BLACKBERRY ESTATES SUBDIVISION

APPLICATION NUMBER 5 DATE May 3, 2018

DETAIL SITE PLAN

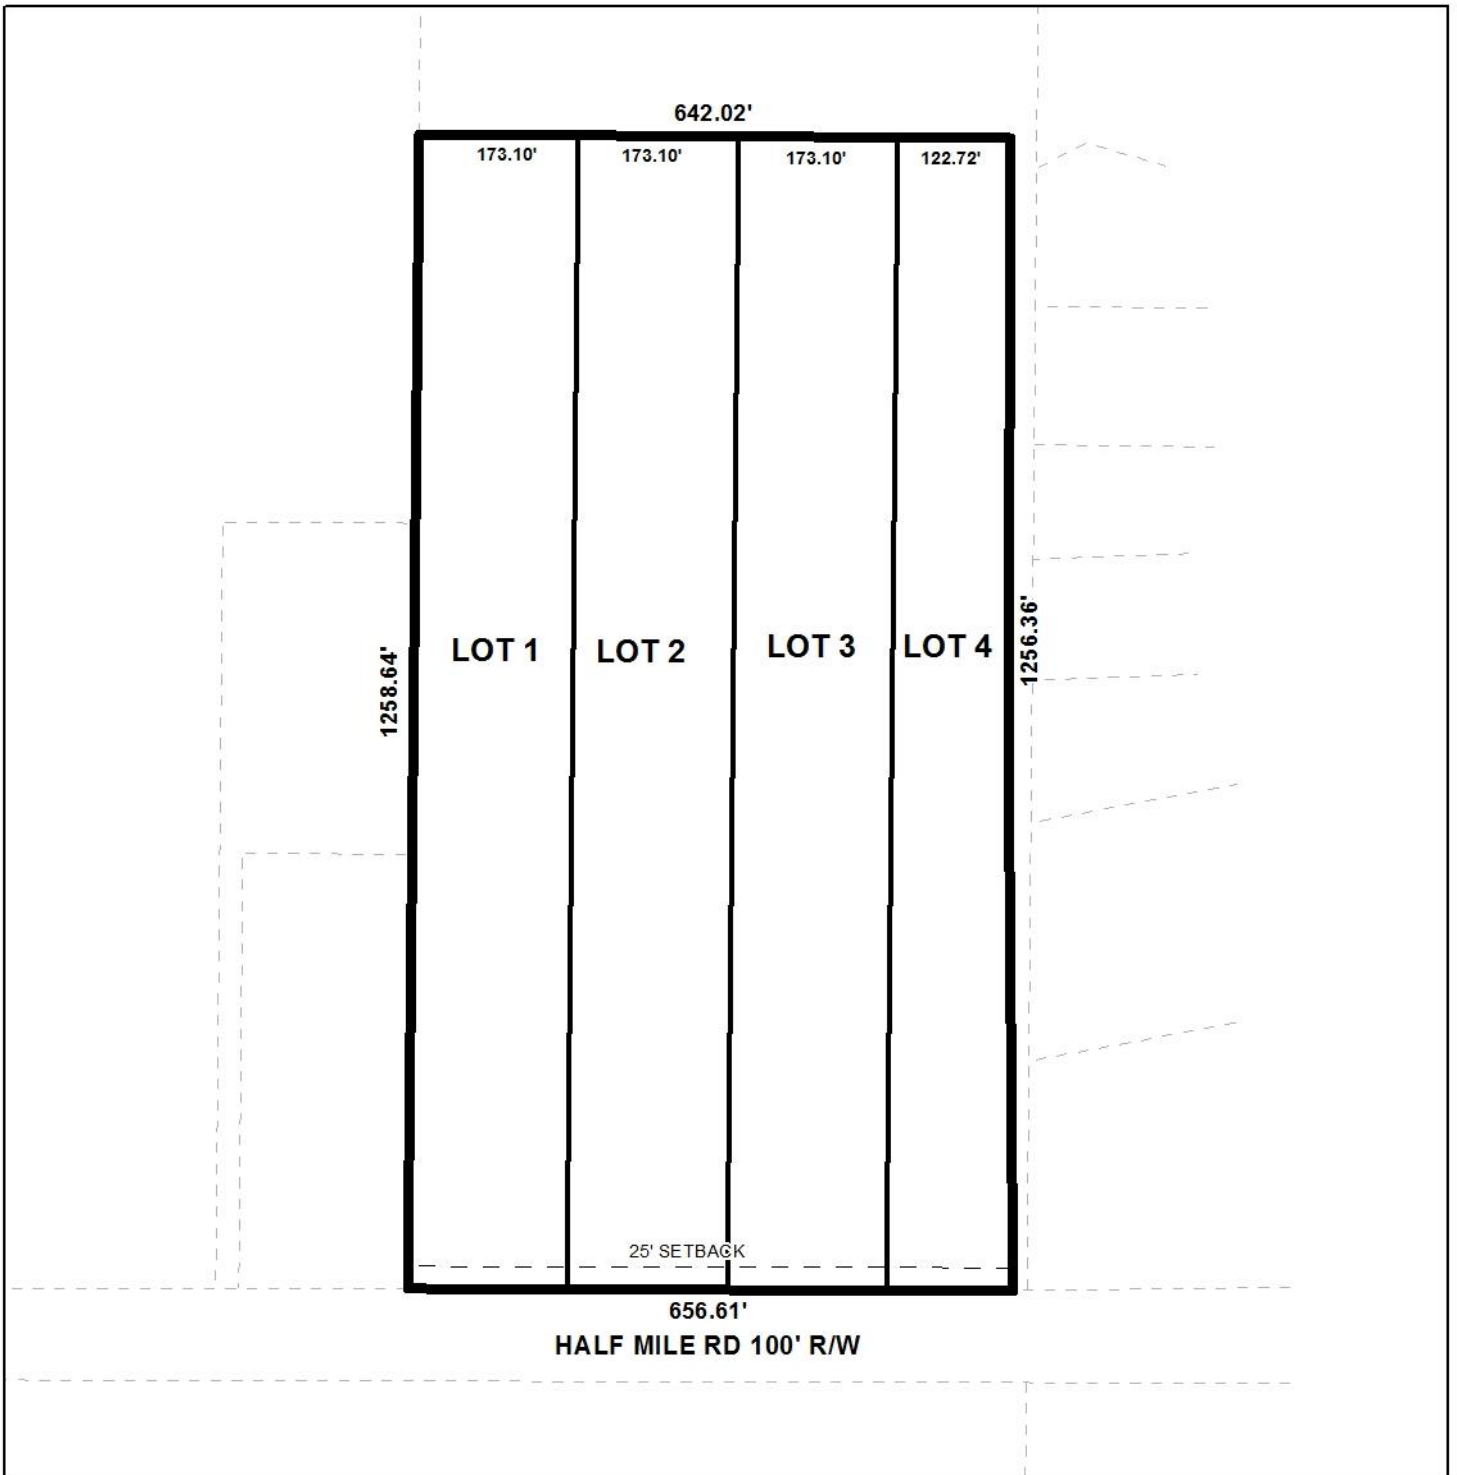
The proposed lots front Half Mile Road, a major street on the Major Street Plan. As a major street, a 100' right of way with is required. The preliminary plat illustrates a 100' right-of-way width for Half Mile Road and, if approved, should be retained on the Final Plat.

The preliminary plat illustrates a 25' minimum building setback line along Half Mile Road along for the proposed Lots 1-4. If approved, the 25' minimum building setback lines for Lots 1-4 should be retained on the Final Plat.

In accordance with Section V.D.2. of the Subdivision Regulations, the proposed lots each exceed the 7,200 square foot minimum lot size requirement for lots served by public water and sewer systems. The lot size information for each lot is depicted in both square feet and in acres on the preliminary plat and should be retained on the Final Plat, if approved.

It should be noted that the proposed lots do not meet the width-to-depth ratio. Section V.D.3. of the Subdivision Regulations states that lot depth should not exceed 3.5 times the width of the lot at the building setback. The proposed lots are all at least 130'± wide and more than 1,250'+ deep, resulting in lots that are approximately 795'± deeper than would normally be allowed. As there are similarly configured lots in the vicinity that have been previously approved by the Planning Commission, a waiver of Section V.D.3. of the Subdivision Regulations may be appropriate.

As a means of access management, a note should be placed on the Final Plat, if approved, stating that each lot is limited to one curb cut each, with the size, design and location of the curb cut to be approved by Mobile County Engineering and conform to AASHTO standards.

This site is located in the County; therefore, any lots which are developed commercially and adjoin residentially-developed property must provide a buffer, in compliance with Section V.A.8. of the Subdivision Regulations. A note should be placed on the Final Plat, if approved.

Based upon the preceding, this application is recommended for Tentative Approval, with a waiver of Section V.D.3. of the Subdivision Regulations, subject to the following conditions:

- 1) Retention of the 100' right-of-way width to Half Mile Road;
- 2) Retention of 25' minimum building setback line along Half Mile Road;
- 3) Retention of the lot size information in both square and in acres on the Final Plat;

- 4) Placement of a note on the Final Plat stating that all lots are limited to one curb cut each, with the size, design and location of the curb-cut to be approved by Mobile County Engineering and conform to AASHTO standards;

- 5) Placement of a note on the Final Plat stating that any lots which are developed commercially and adjoin residentially developed property must provide a buffer, in compliance with Section V.A.8. of the Subdivision Regulations;

- 6) Compliance with Engineering Comments and placement as a note on the Final Plat: *(Must comply with the Mobile County Flood Damage Prevention Ordinance. Development shall be designed to comply with the storm water detention and drainage facility requirements of the City of Mobile storm water and flood control ordinances, and requiring submission of certification from a licensed engineer certifying that the design complies with the storm water detention and drainage facility requirements of the City of Mobile storm water and flood control ordinances prior to the issuance of any permits.); and*

- 7) Compliance with Fire Comment: *(Projects outside the City Limits of Mobile, yet within the Planning Commission Jurisdiction fall under the State or County Fire Code (2012 IFC).*
